**ROAD LAYOUT
HOUSING DEVELOPMENT
FROGSTON ROAD (POD H)
EDINBURGH**

STAGE 3 ROAD SAFETY AUDIT
(SPA Ref No: 4282)

Client: Barratt Homes

Drawing(s): E9876~0925

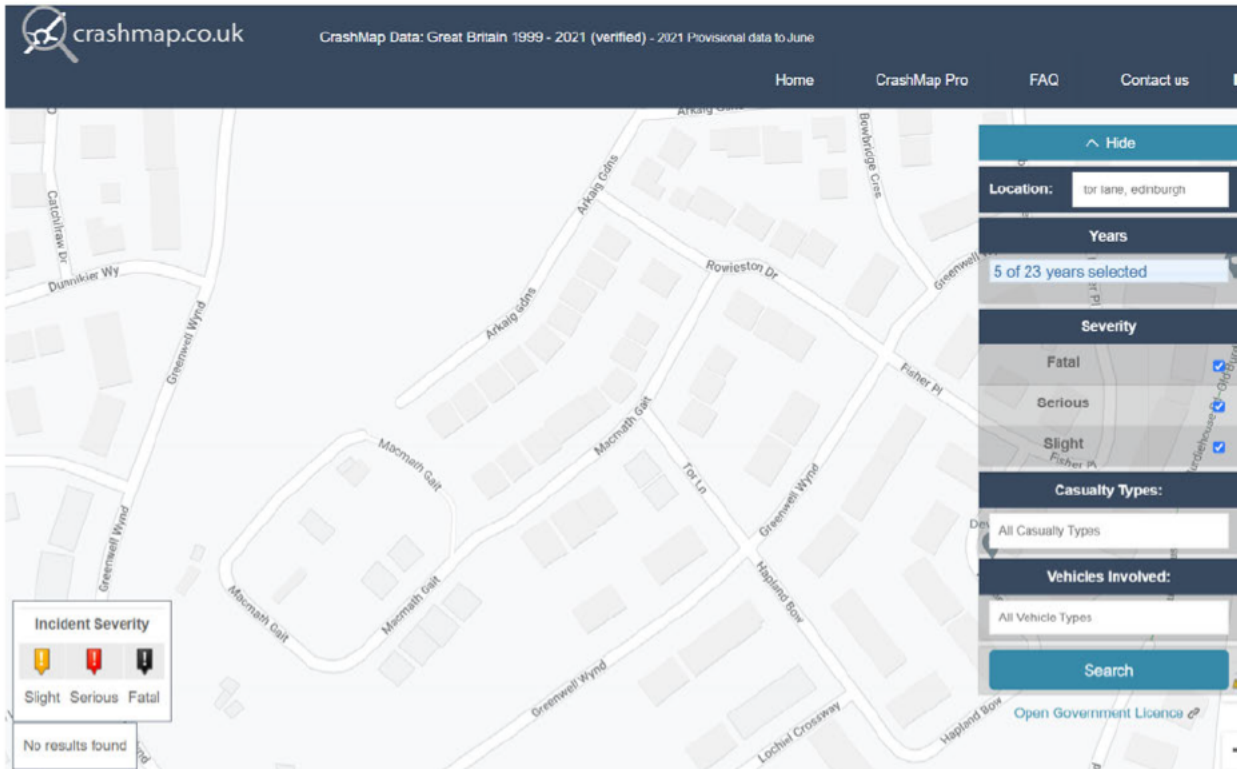
Location: Footpath at east end of Pod I (Arkaig Gardens and Macmath Gait)

Summary: Accessible dropped kerbs at a height of 0-6mm help reduce tripping type accidents and improve accessibility.

It is recommended that the kerb heights on this footpath be reviewed with a view to providing them at an accessible height.
